# Access Compliance Report

## Public Rights-of-Way

Intersection ID: 53414	Main Street: WAVERLY_WALK_AV	Cross Street: SIX_MILE_CREEK_RD	Location: NE
ADA ID: 31B013CD9DBE	Ramp Type: BlendTrans1	Initial Pass/Fail: Fail	Overall Compliance: No
		Severity Score: 10

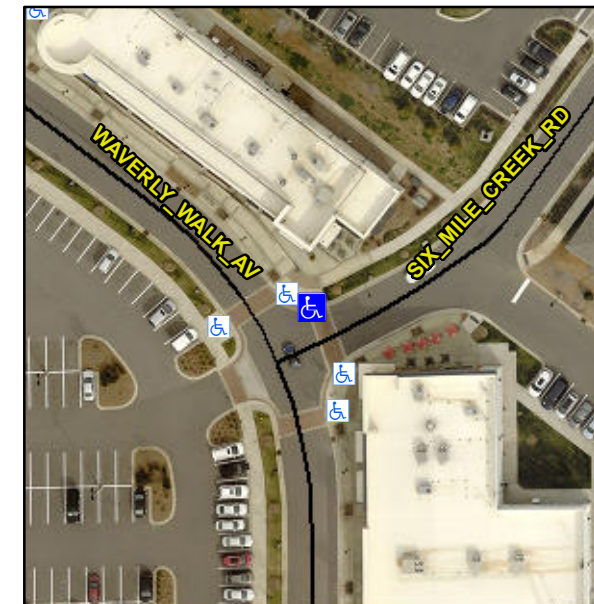
**Not Found, R304.5.1, R304.5.3**

Compliance	Description	Data	Compliance	Description	Data
N/A	Ramp Length (in)	87.0	Yes	BlendTrans Slope (%)	0.8
No	Ramp Width (in)	45.0	No	BlendTrans XSlope (%)	3.7
N/A	Flare Type LT	N/A	N/A	Flare Type RT	N/A
N/A	Flare Slope LT (%)	N/A	N/A	Flare Slope RT (%)	N/A
N/A	Flare Traversable LT?	N/A	N/A	Flare Traversable RT?	N/A
N/A	Landing Length (in)	N/A	N/A	DWS Provided?	N/A
N/A	Landing Width (in)	N/A	N/A	DWS Contrast?	N/A
N/A	Landing Slope (%)	N/A	N/A	DWS Length (in)	N/A
N/A	Landing X Slope (%)	N/A	N/A	DWS Full Width?	N/A
N/A	Landing Curb? (Y/N)	N/A	N/A	DWS Offset (in)	N/A
N/A	Shared Landing?	N/A			
N/A	Gutter Ponding?	N/A	N/A	Gutter Slope (%)	N/A
N/A	Gutter Lip Ht (in)	N/A	N/A	Gutter X Slope (%)	N/A
N/A	Painted X Walk1?	Yes	N/A	Painted X Walk2?	N/A
	X Walk 1 Direction	To SE		X Walk 2 Direction	N/A
	X Walk 1 Width (in)	104.0		X Walk 2 Width (in)	N/A
	X Walk 1 Slope (%)	2.4		X Walk 2 Slope (%)	N/A
	X Walk 1 X Slope (%)	2.6		X Walk 2 X Slope (%)	N/A

N/A	Ramp inside XWalk1?	Yes	N/A	Ramp inside XWalk2?	N/A
	Road Slope (%)	2.6		Clear Space?	N/A
	Road X Slope (%)	2.4	N/A	Clear Space to XWalk (in)	N/A
N/A	Any Obstructions?	N/A	N/A	Storm Grate/Utility Hazard?	N/A
	Obstruction Type			Storm Grate/Utility Type	
		N/A			N/A
			Yes	Surface Condition? (G/P)	Good
			No	Curb Slope (%)	6.0

**Remove & Replace Curb Ramp With Two New Directional Ramps or Equivalent.**
